RARITAN BAY AND SANDY HOOK BAY, NEW JERSEY
FEASIBILITY REPORT
FOR
HURRICANE AND
STORM DAMAGE REDUCTION
PORT MONMOUTH, NJ

ADDENDUM
TO
FINAL FEASIBILITY REPORT
RARITAN BAY AND SANDY HOOK BAY
HURRICANE AND STORM DAMAGE REDUCTION PROJECT
PORT MONMOUTH, NEW JERSEY
(NOVEMBER 17, 2000)

Purpose: To provide information concerning changes to the final report as a result of the policy review for the final report.

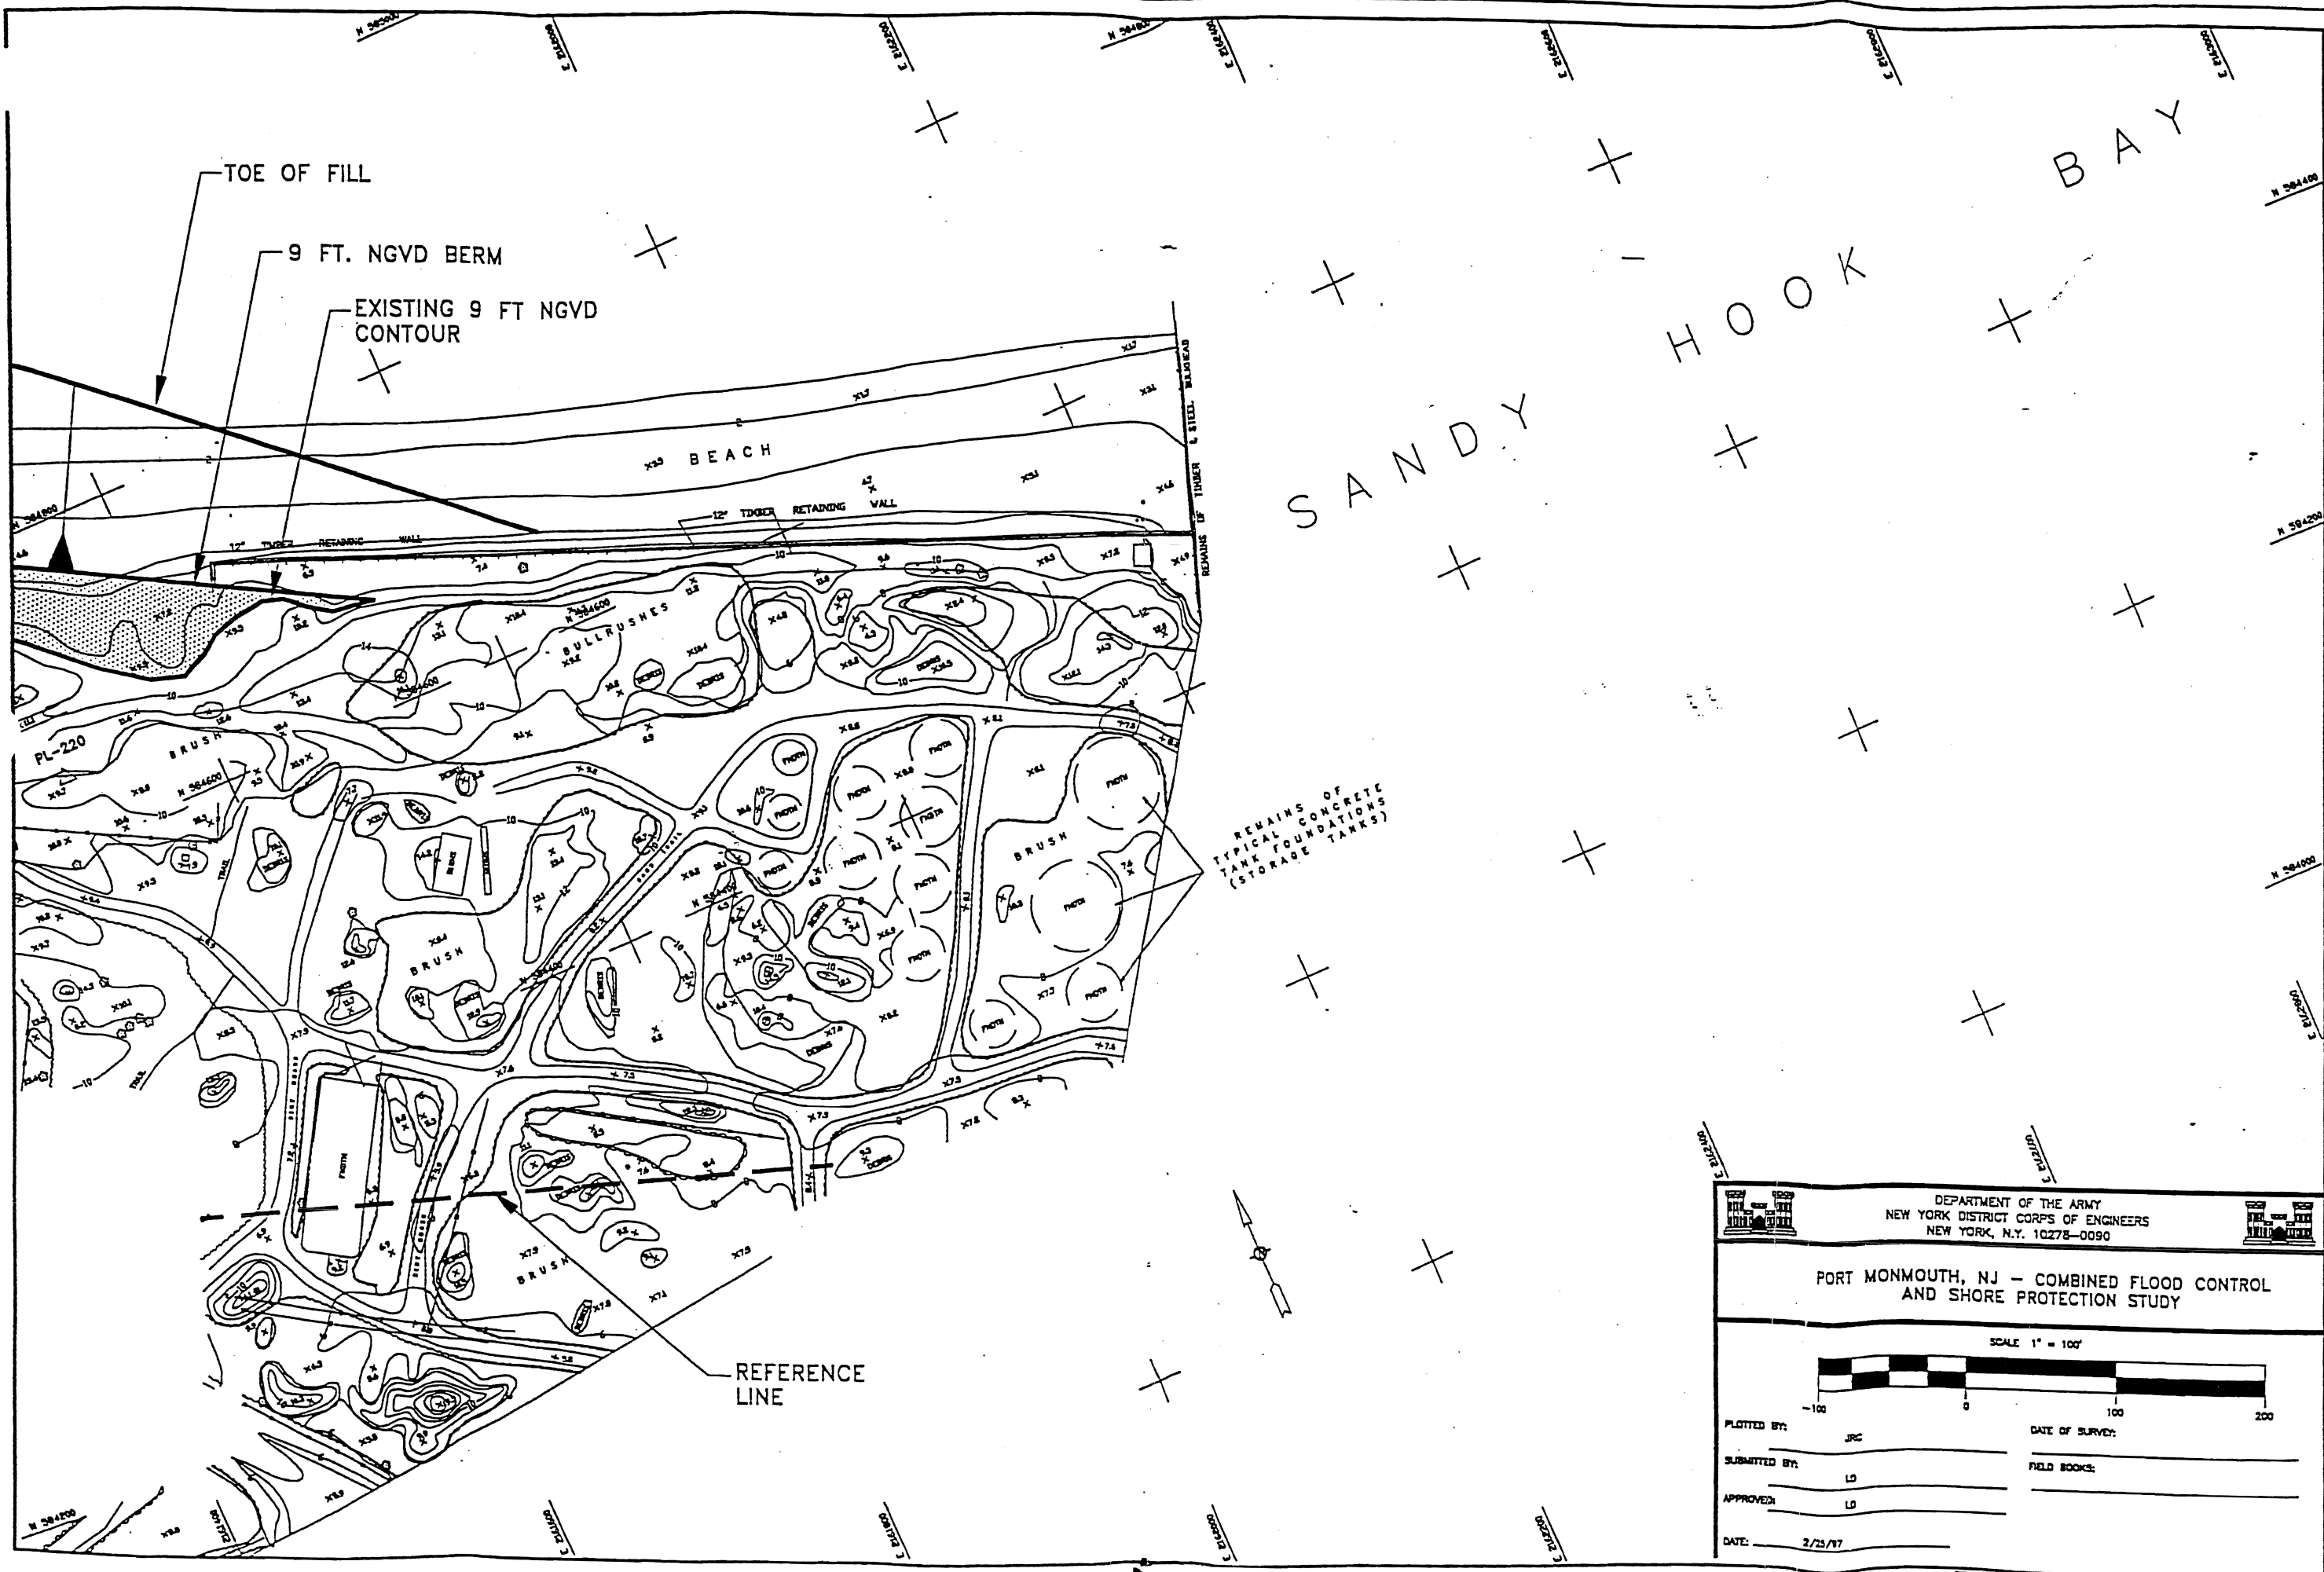
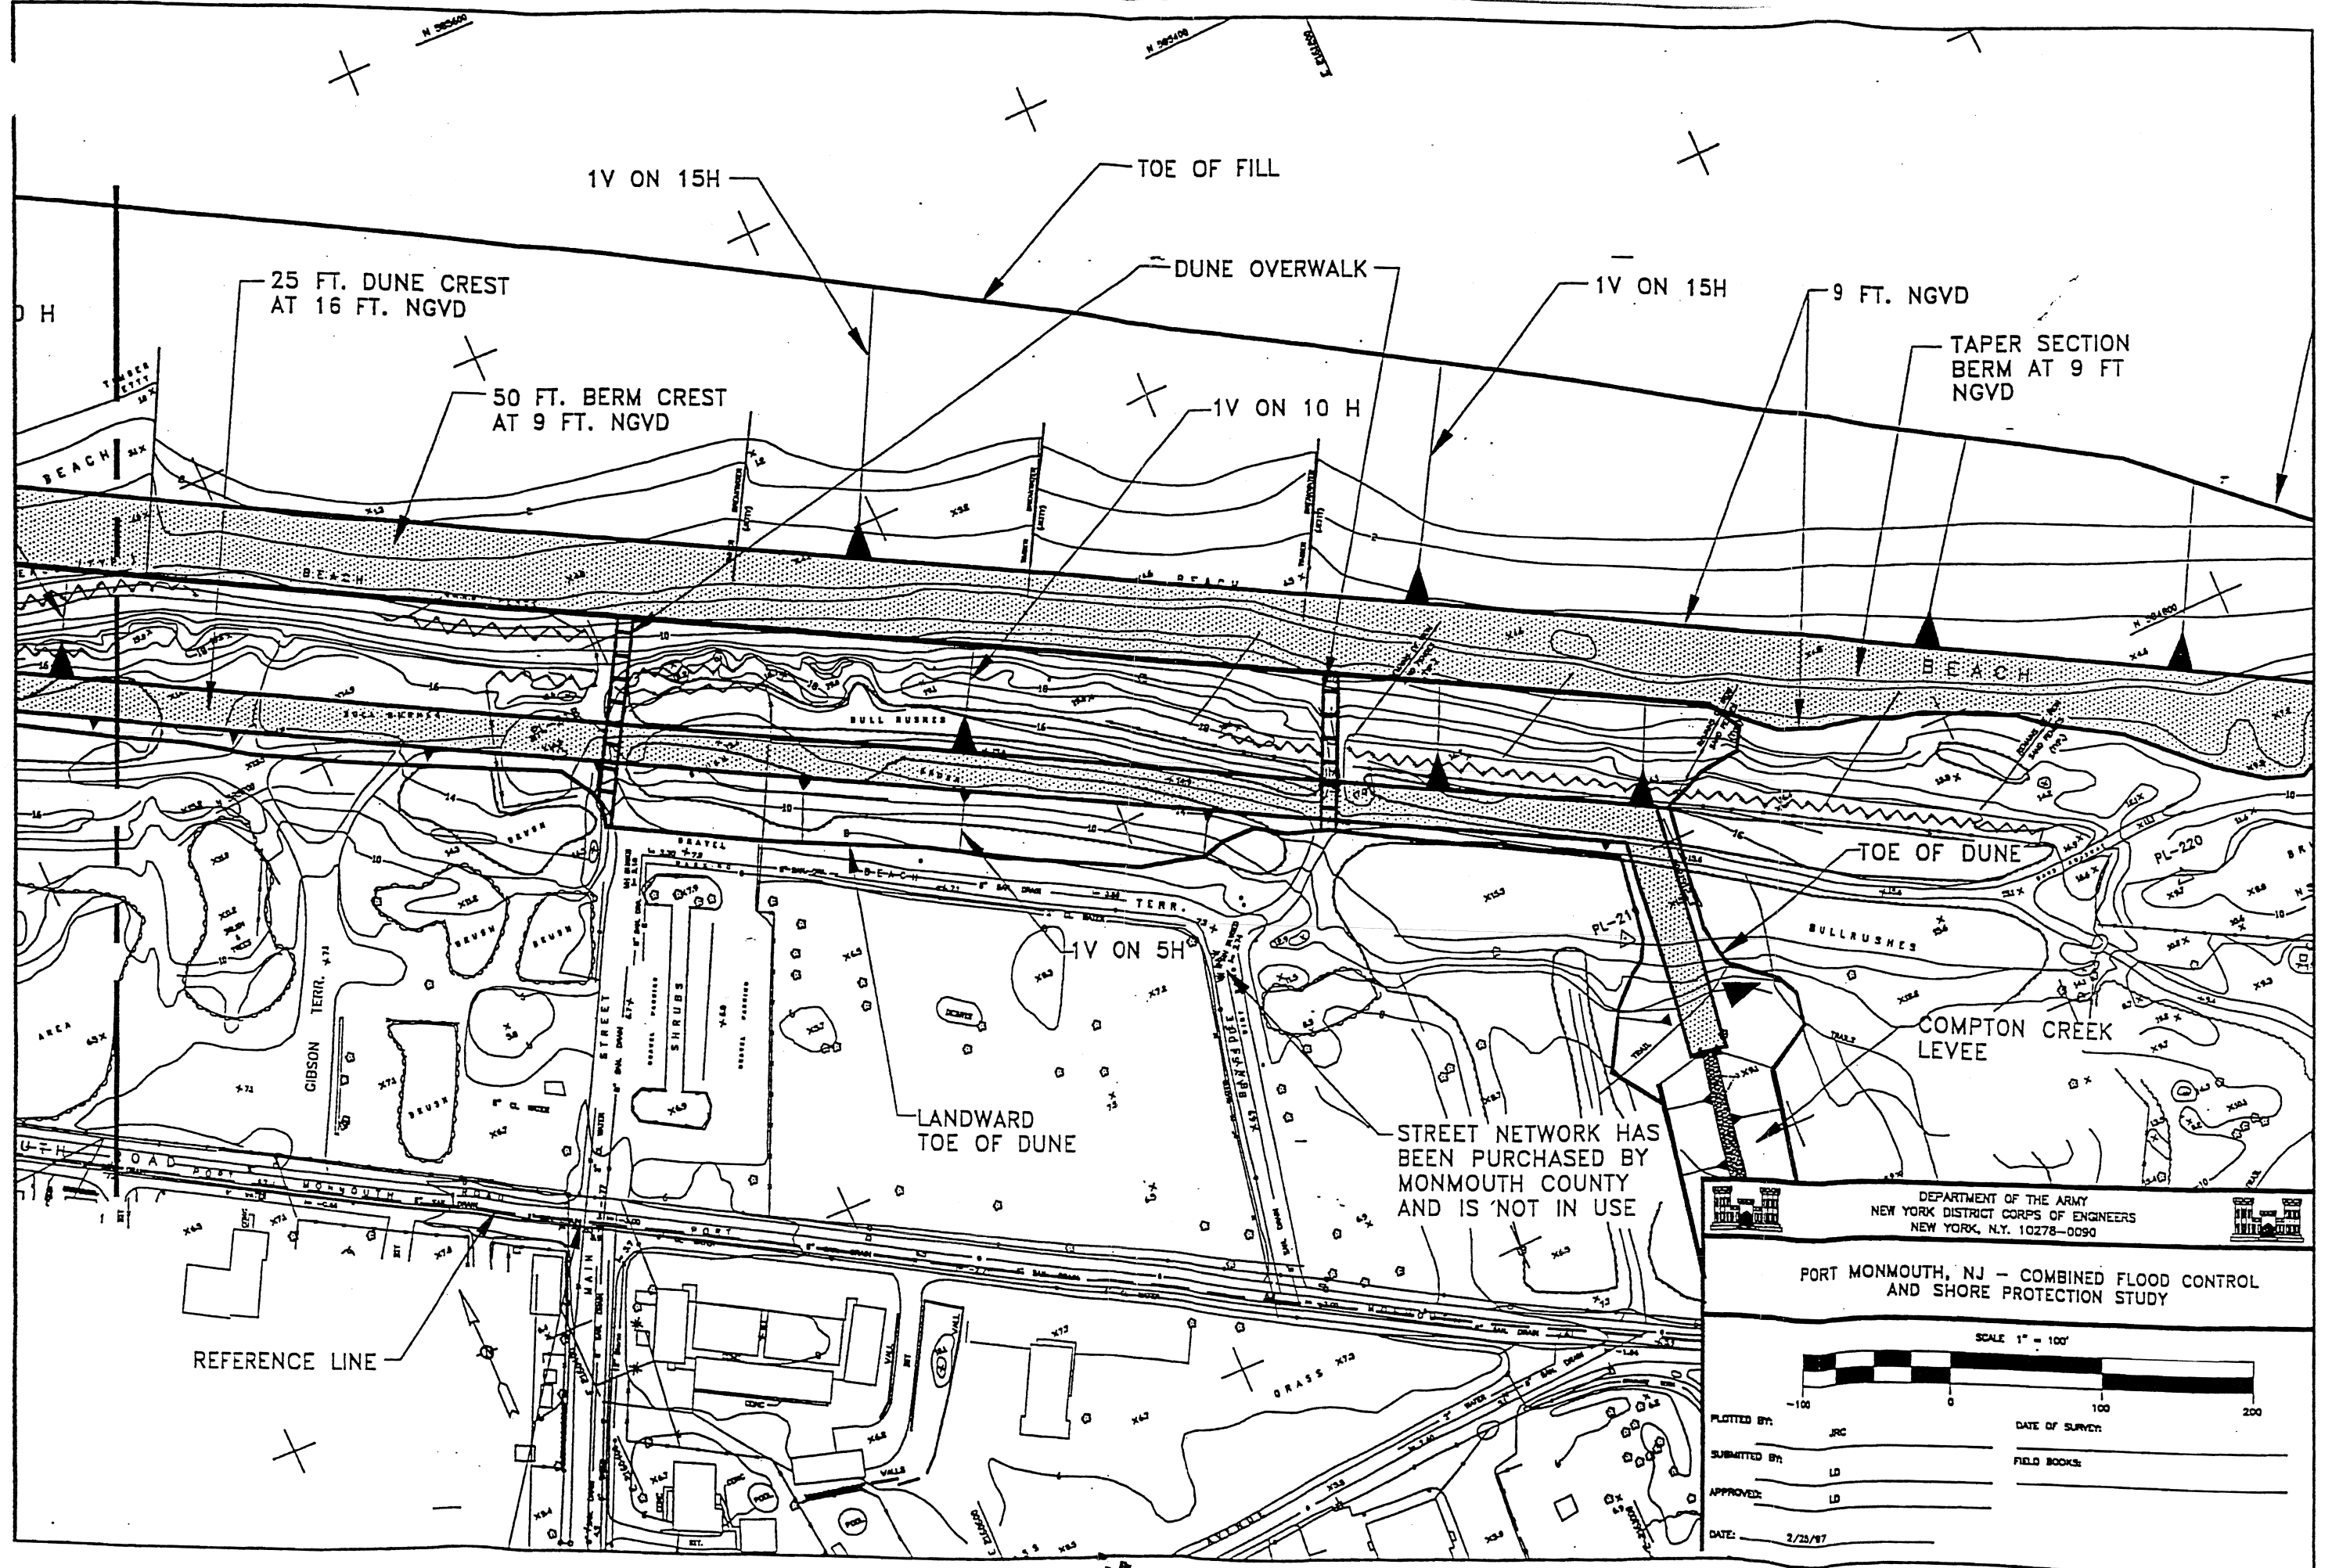
Comment 2: "Impacts on historical landscape – Although the landscape setting of the Seabrook Wilson House has been altered over time, a seawall across the rear yard is objectionable because of adverse impacts on the historic character of the house and its remaining historic landscape. As the imminent owner of the Seabrook Wilson House, the Monmouth County Park System will be making a significant investment in the preservation and enhancement of the site in the years to come; visitors will come to not only see the house but also to enjoy its setting and views. A seawall across the back yard of the site would undermine these preservation objectives. The revised location of the seawall generally along the north side of the fishing pier parking lot, would appear to minimize adverse impacts on the historic landscape. My understanding is that the seawall is to be constructed of steel sheetpiles and poured concrete encased in sand, with a footprint not to exceed 3 feet and a typical wall height of 4 to 5 feet above existing grade. In general, the sand encased seawall, with dune stabilization plantings, should represent a naturalistic dune in its finished appearance. Also, the location of overwalks should be coordinated with the Park System's plans for use of the site and park. However, impacts on the landscape cannot be fully evaluated until additional information is provided. A sectional view at the house, extending from the road to the beach, showing existing/proposed elevations and construction details of the seawall and reconstructed dune, is requested from the Corps of Engineers in order to complete this review."

Response 2: Significant plan modifications in vicinity of the Spy House have been reflected in the current plan which allows for greater lateral clearances and eliminates the seawall. A reconstructed dune at the location of the existing dune will now span the reach between levee tie-offs. A plan view and a sectional view will be provided.
